ADDENDUM NO. 2

PROJECT: Reynolds County Road 364 Bridges

SUBJECT: Project Plans - Barrier Details

MILL CREEK SHOOTS BRIDGE
LAYOUT & DECK DETAILS

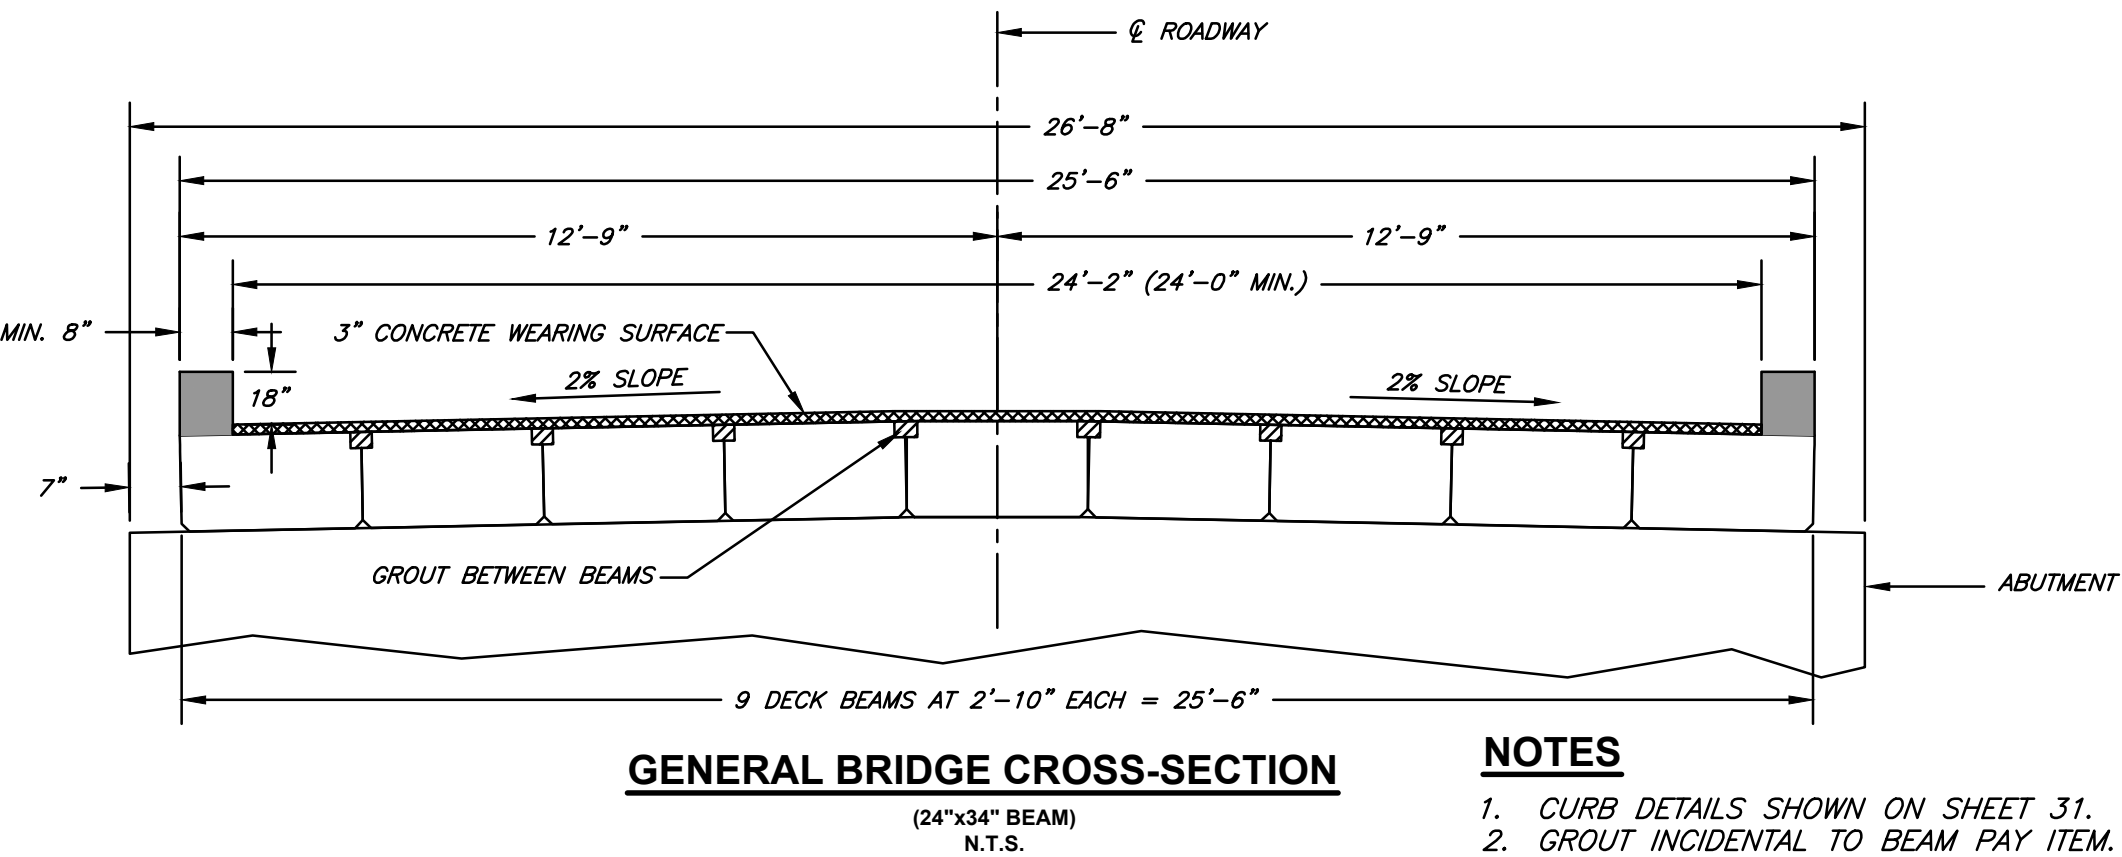
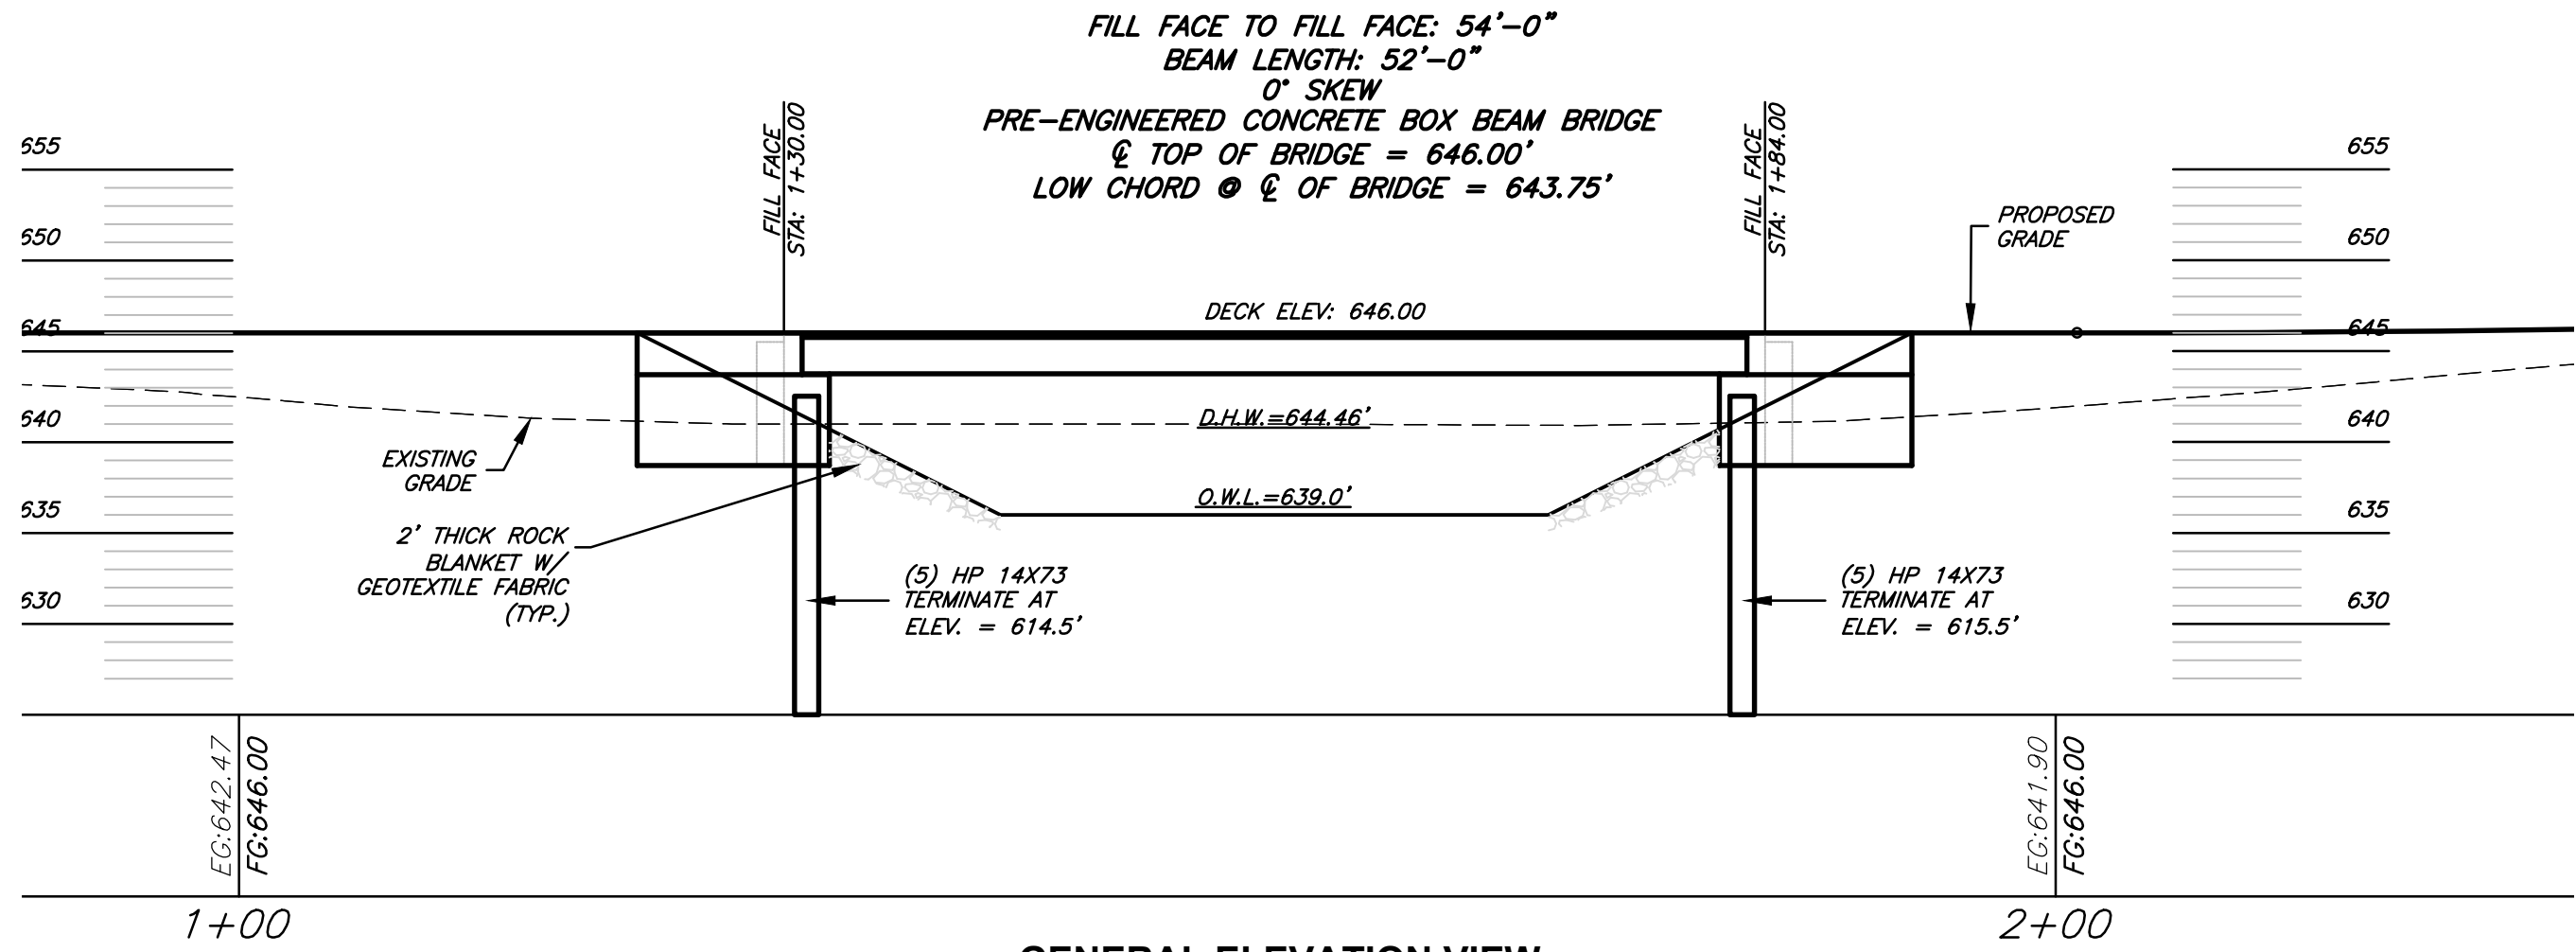
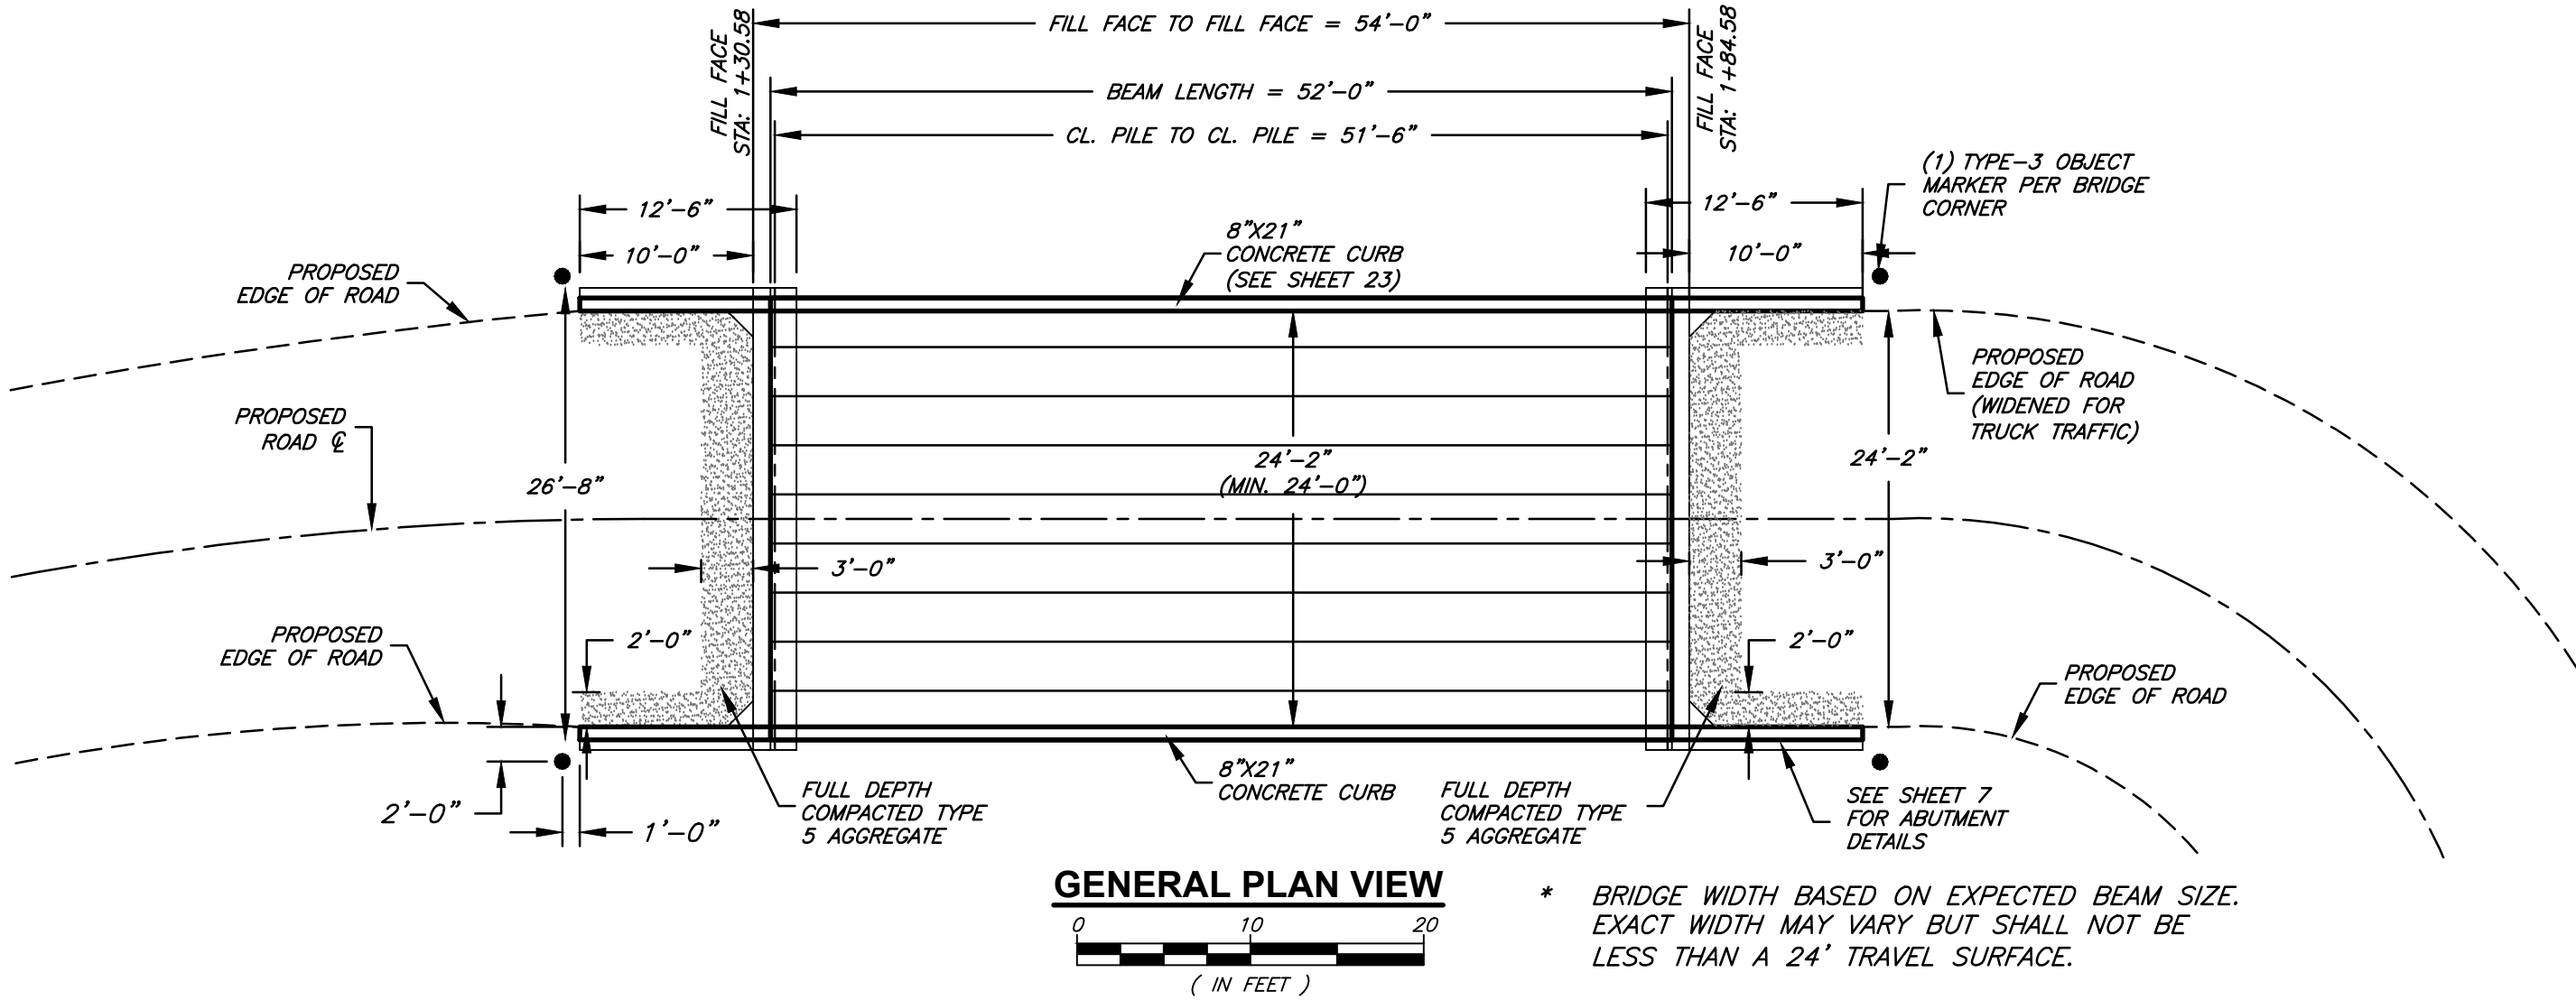
1. Due to a discrepancy, and additional clarification needed for the placement of the barriers, please replace the existing plan sheets **6, 9, 10, 19, 21, 22, and 31** with the attached revised plan sheets.

NO.	REVISIONS	DATE	BY	APP.
1	REVISED BARRIER CURB	12/28/20	JDM	
2	REVISED BARRIER LOCATION	12/28/20	JDM
